AMENDMENTS TO THE DRAWINGS:

Remarks

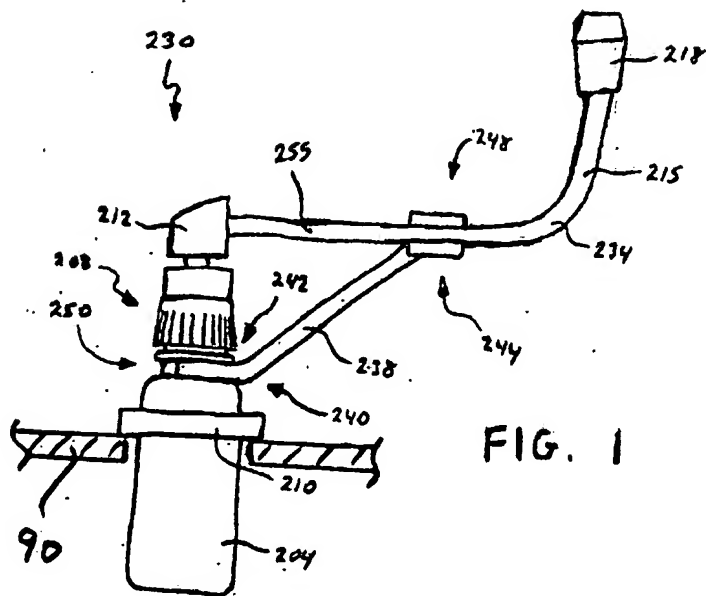
element
90
added

The attached sheets of drawings include changes to FIGS. 1, 2 and 4. These sheets, which include FIGS. 1 through 8, replace the original sheets including FIGS. 1 through 8. In FIG. 1, element 90 with accompanying lead line has been added. In FIG. 2, element 210' with accompanying lead line has been added. In FIG. 4, element 90 with accompanying lead line has been added and element 104 has been revised in placement.

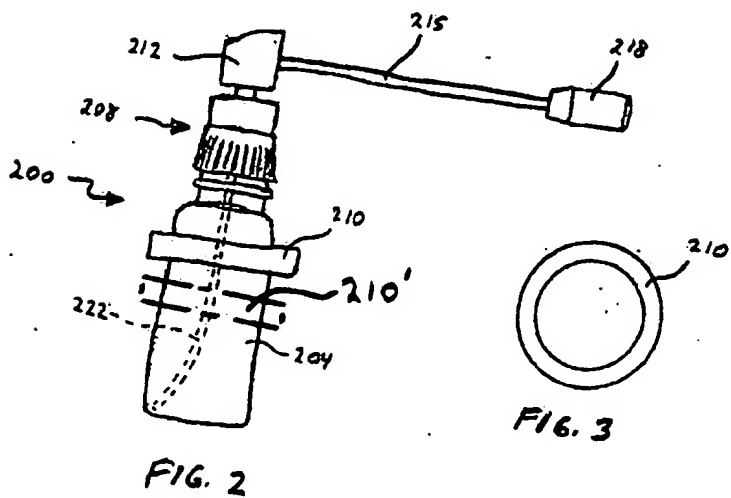
element
210'
added

The objection to the drawings under 37 C.F.R. 1.83(a) is believed to be mooted by submission of the attached replacement sheets. As indicated in red, replacement sheet 1 / 2 includes the addition of a proposed resilient ring 210 disposed at a second position and indicated by numeral 210' in FIG. 2. Support structure 90 is proposed to be added to FIG. 1, in accordance with the Examiner's demand to illustrate a bottle being suspended by a resilient ring in a storage device.
